# VILLAGE OF WAUNAKEE / TOWN OF WESTPORT JOINT PLAN COMMISSION

**TITLE:** Public Hearing and Discussion/Action on a request for approval of a Certified Survey Map and Rezone from A-1 Agricultural Holding to C-1 Commercial for the Proposed Kwik Trip, at the northwest corner of Peaceful Valley Parkway and S. Century Avenue/County Highway Q

**Subject:** Kilkenny West CSM, Rezone, Site Plan Review for Kwik Trip Site

Re: Kwik Trip Site Plan

CONVENIENCE STORE #1094 WITH 1 BAY CARWASH SITE PLAN

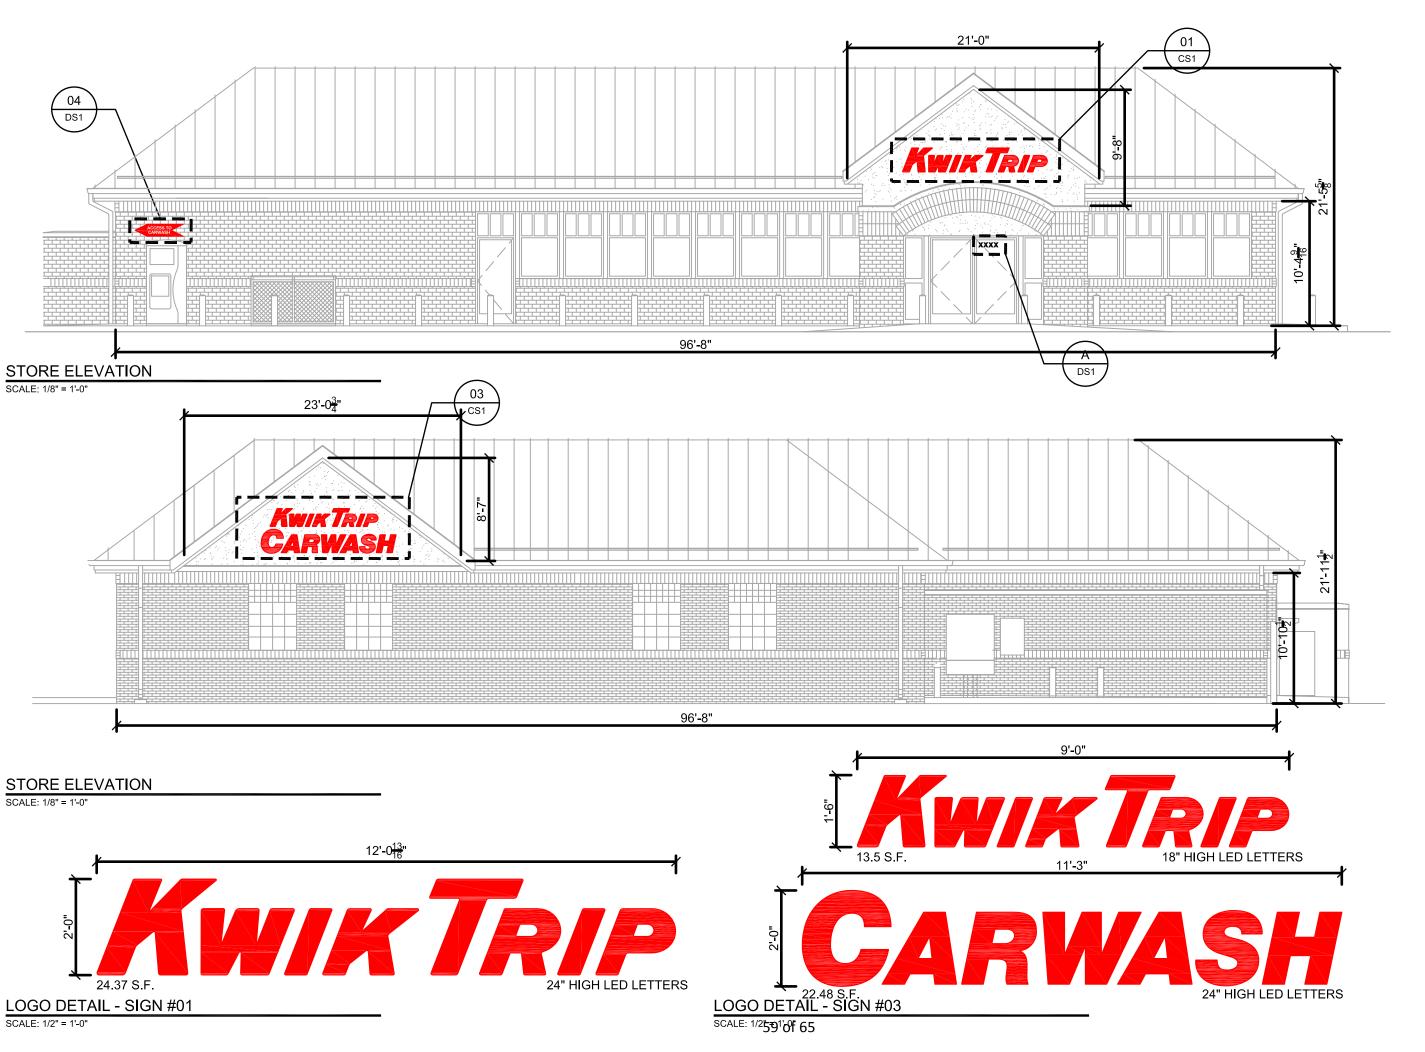
1. Strand's February 26, 2020 review comment—The two driveways on Winn Drive are very close and could cause confusion as to which driveway is going to be used. One of the Winn Drive driveways should be removed and replaced with one on Tullamore Street. Furthermore, the westerly driveway appears to be too close to the intersection of Tullamore Street and Winn Drive. The location of the remaining driveway off Winn Drive should be coordinated to align with the proposed driveway on the south side of Winn Drive shown on the Kilkenny West—Phase 1 drawings for Winn Drive.

2. Strand's February 26, 2020 review comment—The driveways should be constructed with traditional aprons and sidewalks, similar to the current Kwik Trip in downtown. The present design is not appropriate for an urban location with pedestrians and sidewalks.

Strand's current comment-Addressed on Winn Drive, but not at Peaceful Valley Parkway.

9. Strand's February 26, 2020 review comment—The routing of the sewer and water service laterals does not seem efficient. It is suggested that the water service be extended off the existing water main along the west side of CTH Q or to extend off the water main from Winn Drive further to the east such that the service may run along the east side of the building.

10. Strand's February 26, 2020 review comment—Note that the current alignment of the water service appears to be approximately 10 feet from the proposed gas tanks. The Wisconsin Department of Natural Resources (WDNR) requires that a 25-foot setback from gas tanks be maintained. Also is recommended that an alternative route for the sanitary service be considered that avoids multiple bends and a direct connection to the sanitary manhole located at the intersection of Winn Drive and Tullamore Street.

12. Strand's February 26, 2020 review comment–Sidewalk should be extended from the patio area to the sidewalk along Winn Drive.

13. Strand's February 26, 2020 review comment–Stop signs should be added for each proposed driveway.

**Strand's current comment**—The resubmitted sign plan dated April 1, 2020 does not address this comment and should be updated to reflect the new geometric layout of the site.

Snyder's April 23, 2020 response—The driveways have been reconfigured to avoid the conflicts with the corner. Please see the updated plans.

Snyder's April 23, 2020 response—The driveway aprons have been revised.

Snyder's April 23, 2020 response—We have rerouted the sewer and water, please see the attached plans.

Snyder's April 23, 2020 response—We have rerouted the water lateral, please see the attached plans.

Snyder's April 23, 2020 response—A sidewalk has been extended to the multi-use path, please see the updated plans.

Snyder's April 23, 2020 response–No response provided.
